COMMUNITY DEVELOPMENT DEPARTMENT REPORT

HEARING DATE: 3/10/2026
TO: Mayor & City Council
FROM: Nick Napoli, Associate Planner
208-884-5533
Nnapoli@meridiancity.org

SUBJECT: H-2025-0004
St. George

LOCATION: Located at 3870 E. Overland Road and 1545 S. Topaz Avenue in the SE ¼ of the SW ¼ of Section 16, T.3n., R.1E.

D. Site Plan (date: 2/19/2026)

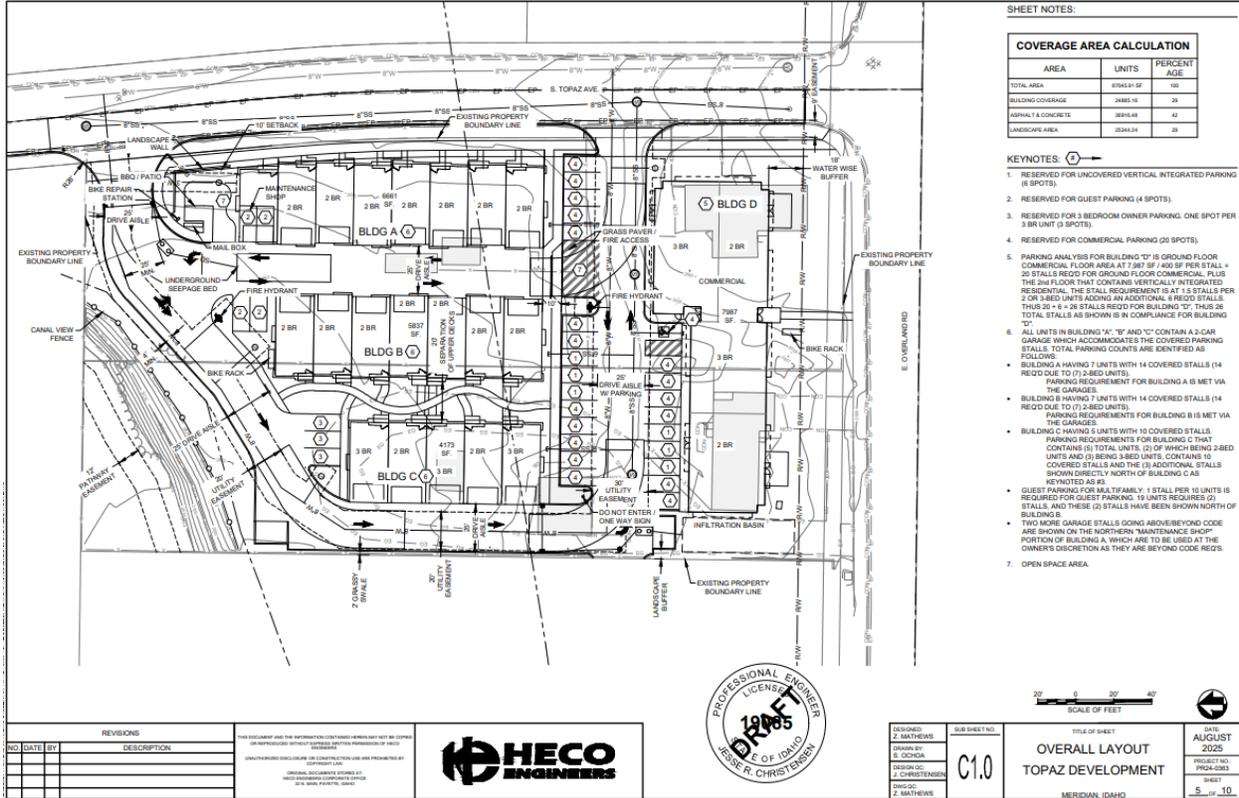
- **The multifamily buildings do not meet the 80-square feet of private usable open space for the residences to use in the multi-family portion of the property. Currently, they are proposing 68 square feet, below the requirement in the UDC.**

- **Water main placement on the west side does not meet the required 4' setback from the curb; inadequate separation from the infiltration trench; fire hydrants not shown, raising easement and spacing concerns; easement area limits the ability to meet landscaping and tree requirements.**

- **Proposed balconies/porches may encroach into 20' sewer easement; landscaping within the easement is not allowed, preventing compliance with UDC 11-3B-12.**

The site plan depicts screened trash enclosures not visible from a public street; all proposed transformer/utility vaults and other service areas shall comply with this requirement.

*The floor plan depicts 68 square foot patios or decks for each unit that does not comply with this standard. **Staff is not supportive of reducing the private usable open space for this project.***

The common open space areas depicted for the development do not meet this requirement. The open space depicted on the south portion of Five Mile Creek does not exceed twenty (20) feet in width.
- 7. In phased developments, common open space shall be provided in each phase of the development consistent with the requirements for the size and number of dwelling units. *Not applicable; the development will be completed in a single phase.*
- 8. Unless otherwise approved through the conditional use process, common open space areas shall not be adjacent to a collector or arterial streets unless separated from the street by a berm or constructed barrier at least four (4) feet in height, with breaks in the berm or barrier to allow for pedestrian access.

Landscaping is required to be provided along all parking areas per the standards listed in UDC 11-3B-8. *The proposed landscape plan does not meet the minimum requirements. Several planter islands and landscaping areas are missing trees or other vegetation due to easements. The Public Works Department expressed concerns regarding proposed landscaping and easement locations as there is also proposed landscaping*

The landscape plan does not meet the minimum requirements for the zoning being requested. The applicant cannot place trees in the landscaping on the west portion of the site due to a proposed reduction from five (5) feet in width to two (2) feet in width.

The applicant does not meet the pathway landscaping requirements and shall revise their site and landscape plan to reflect compliance with these standards. A minimum of ten (10) feet of landscaping is required along pathways with no less than two (2) feet on any one side.

If approved, the applicant shall provide vegetation coverage calculations with the submittal of the certificate of zoning compliance submittal and shall provide a tree in each planter island. If a tree cannot be placed in a planter island due to an easement, relocation of the tree elsewhere on site will be required.

1. The site and landscape plan shall include the following revisions:
 - Depict all proposed fencing and provide a fencing exhibit.
 - Implement directional signs and striping to indicate the northern entrance off of Topaz Avenue as one-way.

- Provide parking lot landscaping in accordance with UDC 11-3B-8 or apply for alternative compliance to relocate the trees to the buffer along Overland Road.

- Provide bicycle parking for the multi-family and non-residential uses in compliance with UDC 11-3C.
 - Leave Five Mile Creek in its natural state and remove the northernmost unit in Building A to incorporate additional open space, and relocate the three (3) amenities, one from each category, be relocated to the open space south of Five Mile Creek.

10. **Fifteen (15) days prior to the City Council hearing, the applicant shall provide the revised concept plan, landscaping plan and open space exhibit to match, provide details for the amenities, and relocate the open space.**

F. Qualified Open Space Exhibit (date: 2/19/2026)

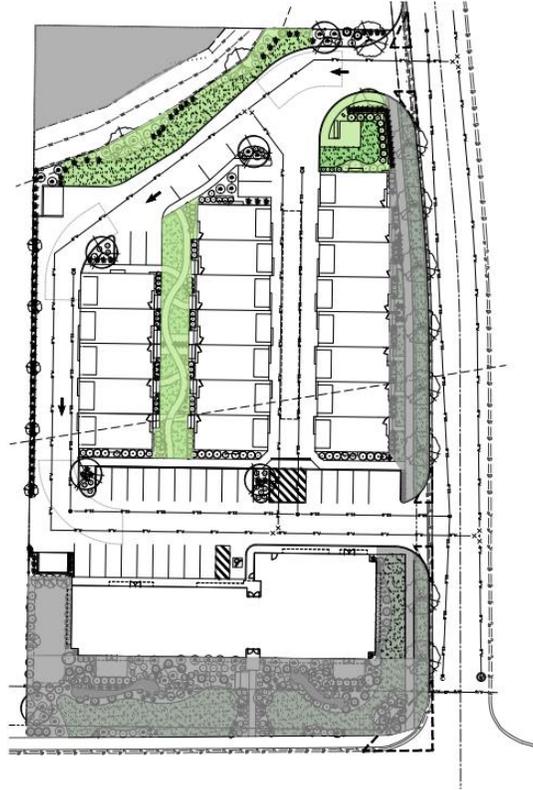
The applicant does not meet the standards listed above, as the primary common open space along Five Mile Creek is not functionally integrated in the design and is not the priority in the design of the development. The common open space does not provide adequate space for a range of leisure and play activities without conflicts with either drive aisles or Five Mile Creek. In addition, the bridge across Five Mile Creek may or may not be approved by the Nampa Meridian Irrigation District, which is crucial to the open space proposed.

A total of 8,330 square feet is proposed, which exceeds the minimum standards. However, the proposed open space does not meet the standards listed above in section two (2) of the open space requirements. The open space does not integrate with the development to promote leisure and play activities without conflicting with drive aisles and Five Mile Creek.

Staff has concerns with the location and functionality of the open space, as Five Mile Creek and the northernmost drive aisle create conflicts for residents to use the open space. Additionally, the plan indicates that a pedestrian bridge is proposed across the Five Mile Creek. If this isn't allowed by NMID, it further impacts the viability of usable open space on the site. The Planning and Zoning Commission and City Council should carefully consider whether the amount and location of the open space is appropriate and whether units should be lost to incorporate more.
